MEMORANDUM

PROJECT: SCEGGS
JOB NO.: 160441

Date: 15 January 2020

SUBJECT SCEGGS DARINGHURST SSD-8993 – REQUEST FOR ADDITIONAL INFORMATION

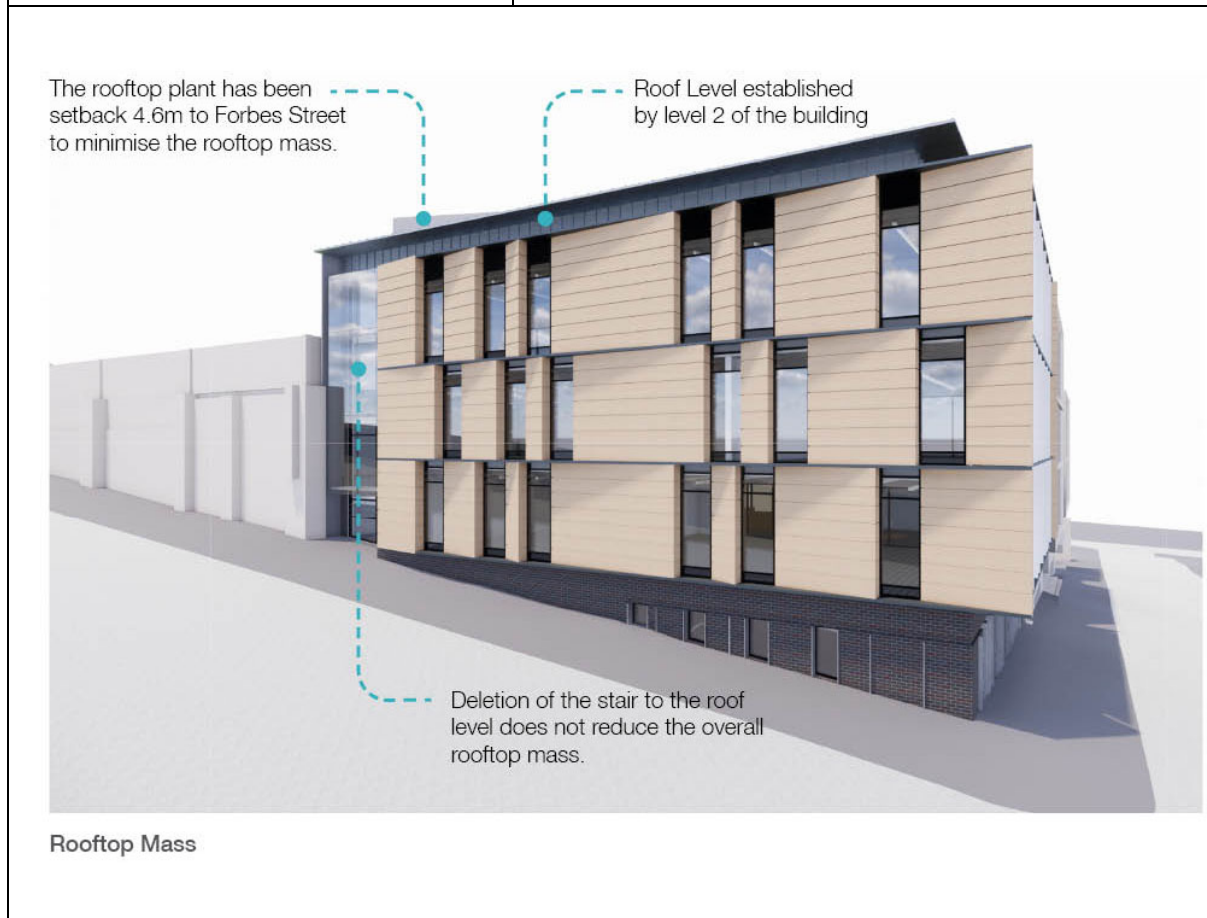
Built Form	
<p>3. Justify the need to provide a fully covered stair core and lift access to the roof level of Wilkinson House. In the interest of reducing the rooftop mass, the Department recommends these accesses be removed and replaced with either a hatch or more discrete access arrangements.</p>	<p>The lift will not provide access to the Level 3 roof level. The lift shaft continues into the Level 3 plan in order to accommodate the lift overrun within the existing mass of the rooftop plant and so that it does not project above this.</p> <p>Stair access is required to provide adequate and safe access to the roof plant level for the maintenance and servicing of plant, equipment and the roof. Stair access is also required in order to provide egress from the roof plant room and meet the requirements of the BCA (a hatch or ladder does not comply with BCA D1.16).</p> <p>Removing or relocating the stair does not reduce the overall mass. The overall mass of the building has been defined by the roof level above Level 2 and to accommodate the Level 3 roof plant. The stair has been designed to fit within this envelope and the deletion of the stair to the roof level does not reduce or change the overall rooftop mass.</p> <p>The overall mass of the rooftop plant has been reduced by including a significant 4.6m setback to Forbes Street, meaning that its mass has been significantly reduced.</p> <p>The overall mass of the building fits within the permitted 15m height limit.</p>

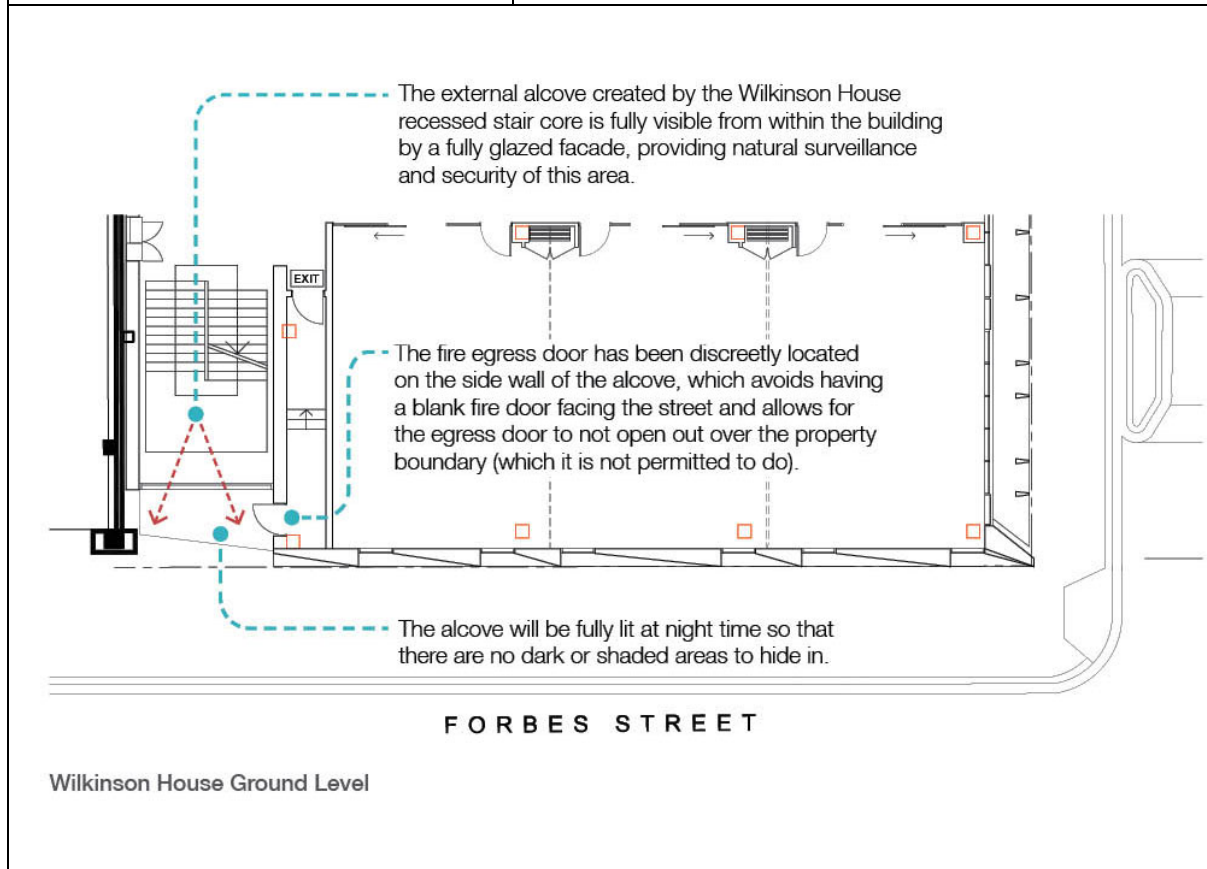
4. Confirm how the alcove created by the Wilkinson House recessed stair core on the Forbes Street frontage would be treated to prevent anti-social behaviour / litter and the like.

The stair core has been recessed from the Forbes Street Boundary in order to:

- 1) create a visual separation between the building and the adjacent Centenary Sports Hall and modulate the high-quality facade.
- 2) allow for the fire egress door to be discreetly located on the side wall of the alcove, which avoids having a blank fire door facing the street and allows for the egress door to not open out over the property boundary (which it is not permitted to do).

The external alcove created by the Wilkinson House recessed stair core is fully visible from within the building by a fully glazed facade, providing natural surveillance and security of this area. The alcove will also be fully lit at night time so that there are no dark or shaded areas to hide in.

The school take pride in maintaining their buildings and keeping the campus clean and litter would be cleaned away as part of the school's daily maintenance and cleaning regime.

The alcove is similar to the alcove located at the entry to the Joan Freeman Building on St Peter's Street, which similarly has good natural surveillance and lighting. The school have had no issues here with anti-social behaviour or litter.

Wilkinson House Level 3 Roof Level

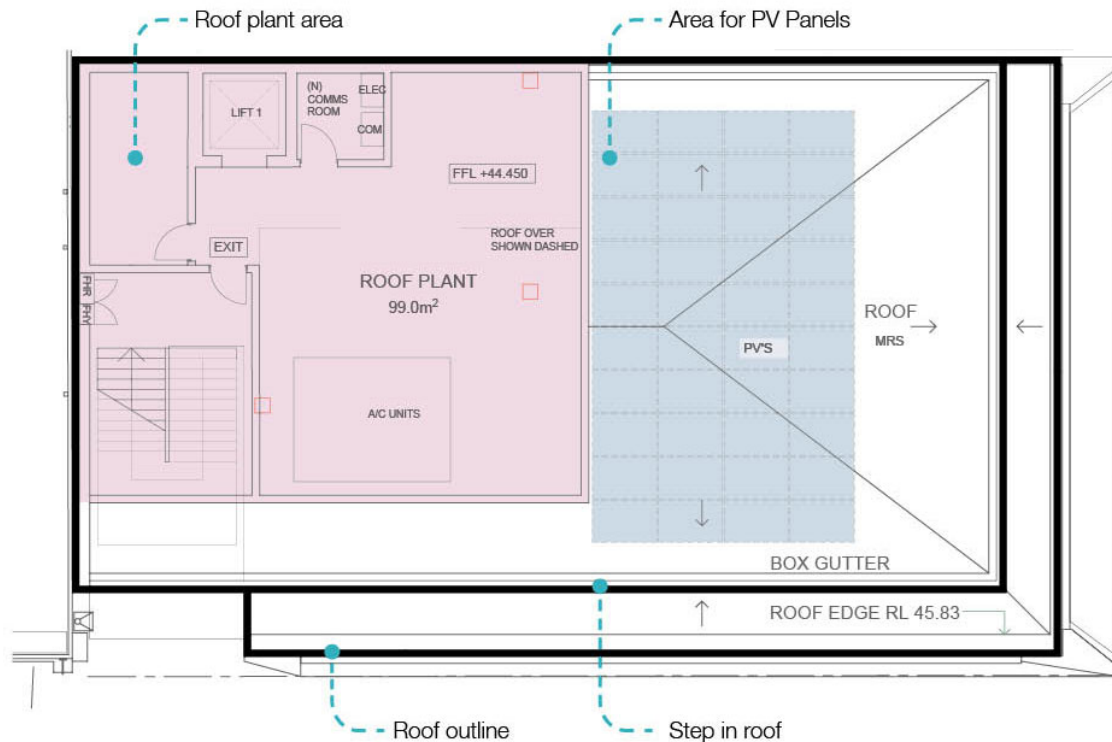
5. Provide justification for not including a green roof on the roof and/or roof plant enclosure of Wilkinson House.

A roof plant enclosure has been provided at the roof level and is shown on Architectural Drawing AR.DA.2015. The roof plant takes up approximately half of the roof area. The majority of the remaining roof area has been used to accommodate PV panels meeting the environmental initiatives of the project.

Given that the roof area is largely occupied by services and plant, the provision of a green roof within the remaining area is not justifiable.

The school intend to provide a green roof as part of the Multi-Purpose Building development, which provides a much larger roof area and will be of greater benefit to the school and neighbours.
